STADIUM SCOREBOARD REPLACEMENT AT VENTURA HIGH SCHOOL

BID # E7-24

ADDENDUM #02

Bid Addendum 2
DATE: September 16, 2024

AS-1.0

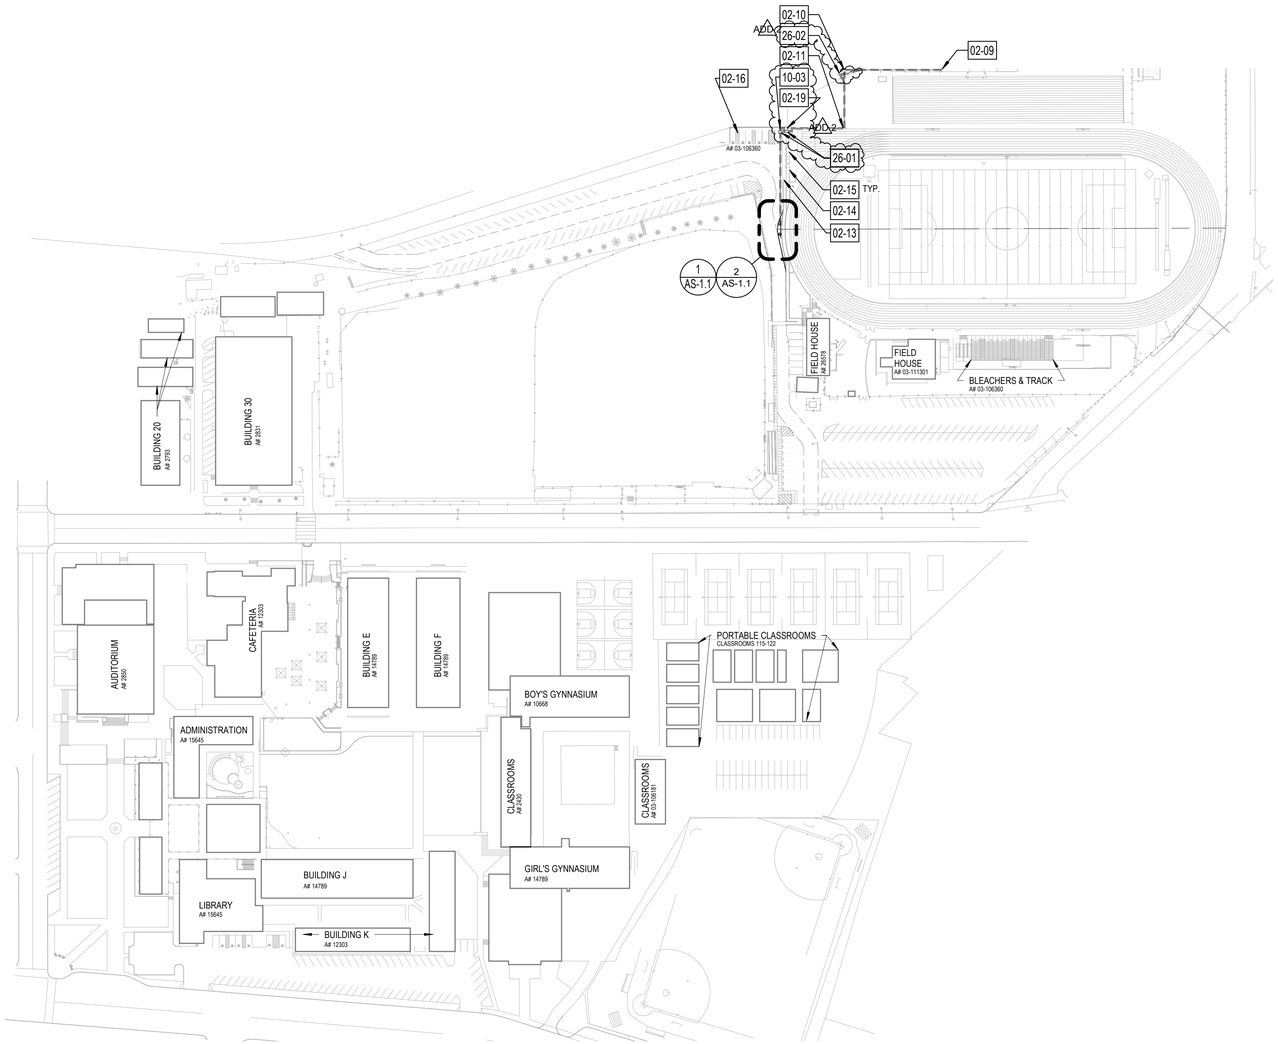
- **Item 1.** AS-1.0: Added data and power pullboxes on North-East side of Site Plan. Refer to added keynote 26-01.
- **Item 2.** AS-1.0: Added flush pullbox on North-East side of Site Plan. Refer to added keynote 26-01.
- **Item 3.** AS-1.0: Added existing power poll, refer to added keynote 02-19.
- **Item 4.** AS-1.0: Added keynote 10-03.
- **Item 5.** AS-1.1: Added additional speed hump on North side of scoreboard.
- **Item 6.** AS-1.1: Updated keynote 02-01.
- **Item 7.** AS-1.2: Added security cameras, dimension and note on Scorebaord Section 1 and 2.
- **Item 8.** AS-1.2: Added detail 20.

EV-2.0

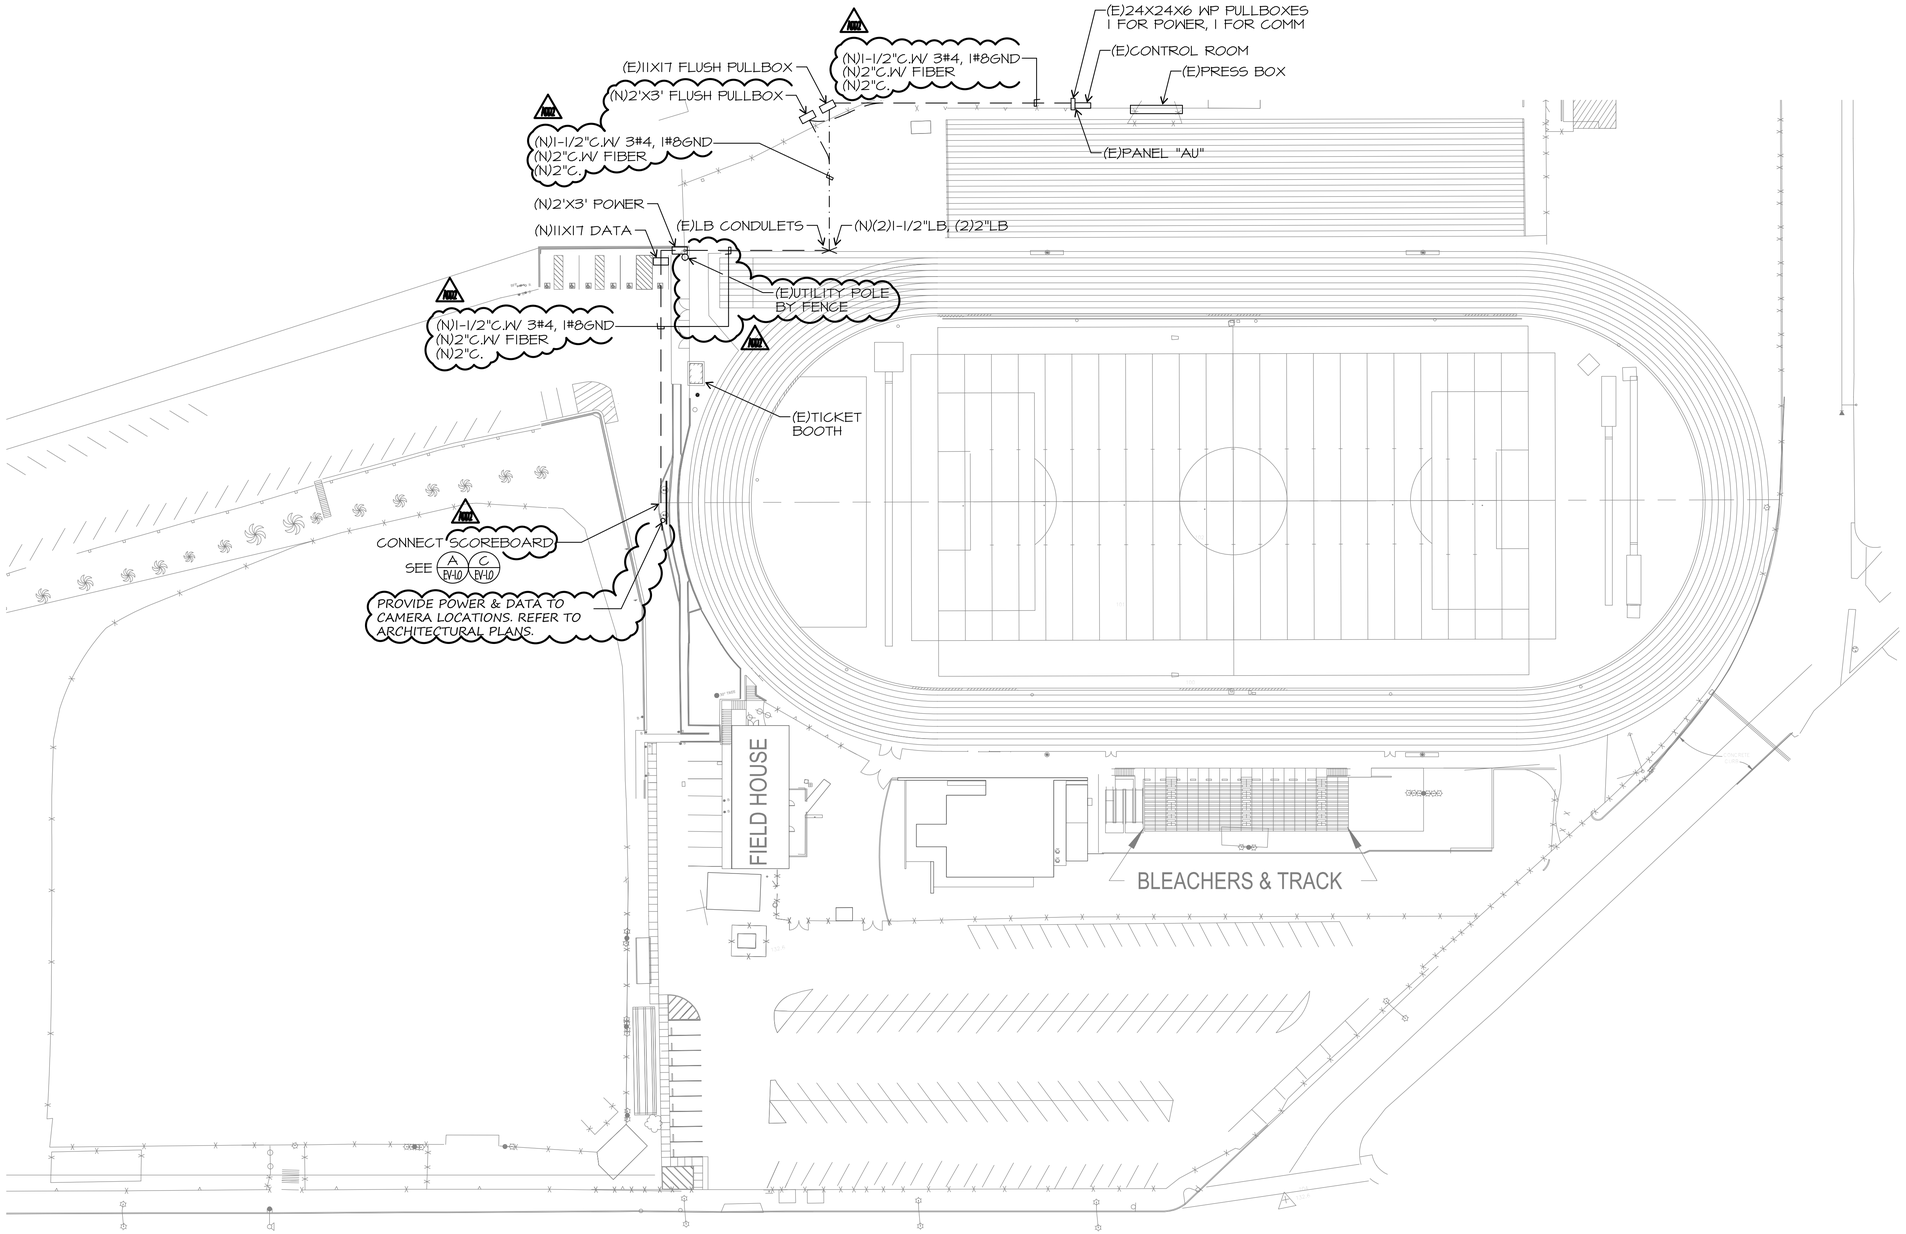
- **Item 9.** EV-2.0: Added power poll
- **Item 10.** EV-2.0: Added flush pullbox on North-East side of Site Plan
- **Item 11.** EV-2.0: Added note for reinstallation of existing camera.
- **Item 12.** EV-2.0: Updates notes for sizes of conduits through the area of work.
